S16YU

Subject: S16YU, Rear Air Disc Brake Axle Shaft Flange Gasket Replacement
S16YU Replaces S16YN

Models Affected: Model Year: Certain 2015-2017
Model: Vision and All American
School Bus and Non-School Bus

REAR AIR DISC BRAKE

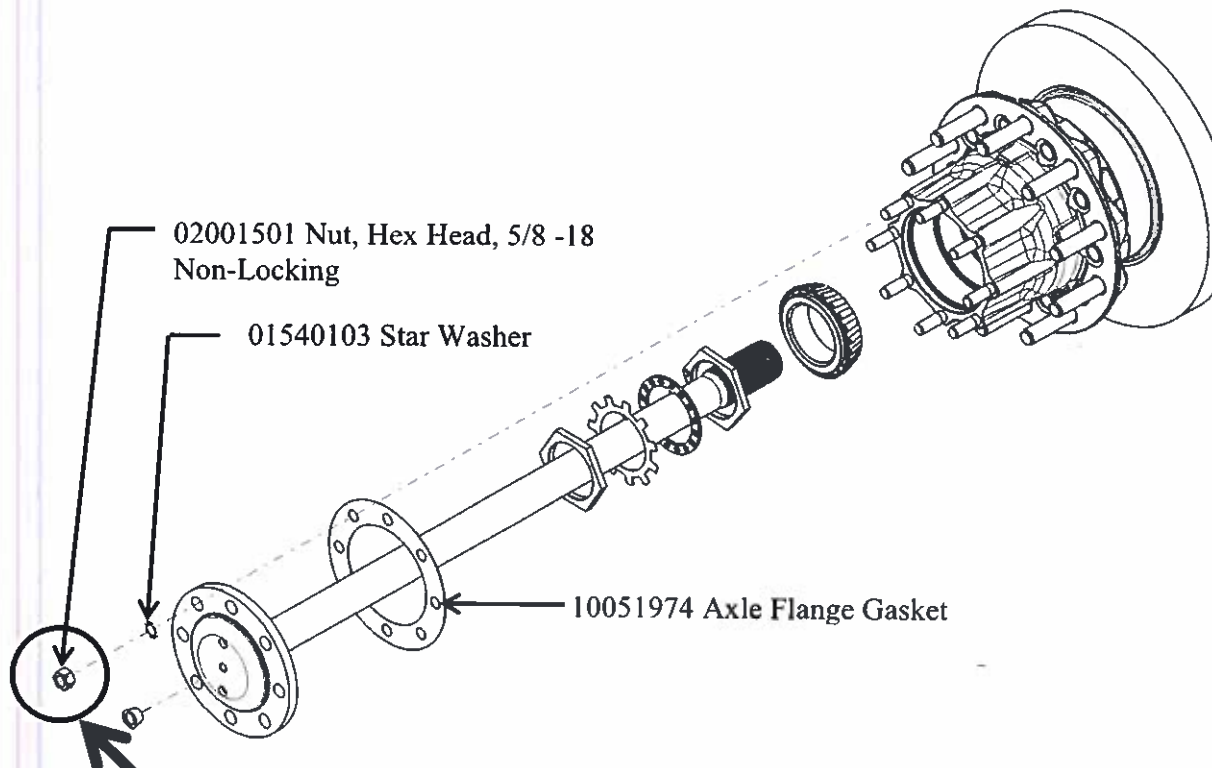
ISSUE	CORRECTIVE ACTION
Rear axle shaft flange gasket torque relaxes allowing for possible oil leak between the axle shaft and hub.	Replace the existing rear axle flange gasket with a new gasket and with new star washers. If the original locking nut has not been replaced with a new non-locking nut, replace locking nuts with non-locking nuts.

If there are locknuts on the rear axle studs, remove and discard lock nuts and washers.

1. Park bus on level surface, turn off engine, remove ignition key, and chock wheels.
2. To reduce the possibility of the stud being removed when removing nuts with paint, remove the paint from the existing rear axle shaft flange studs.
3. Remove all (8) eight nuts and star washers on both sides. Replace existing axle flange gasket with new 10051974 gasket on both sides and install axle shaft. If a stud comes out during removal of nut, remove the nut from the stud and reinstall the stud into the hub. Torque stud to 60 to 70 ft-lb.
4. If the bus has the original locknuts, replace with new non-locking nuts. Install eight (8) new star washers 01540103 and eight (8) non-locking nuts 02001501 (removed from axle studs) on both sides.
5. Torque nuts to 60-70 ft-lb.
6. Re-torque all nuts to 170-180 ft-lb. in a "star" pattern.

Non-locking nut 02001501
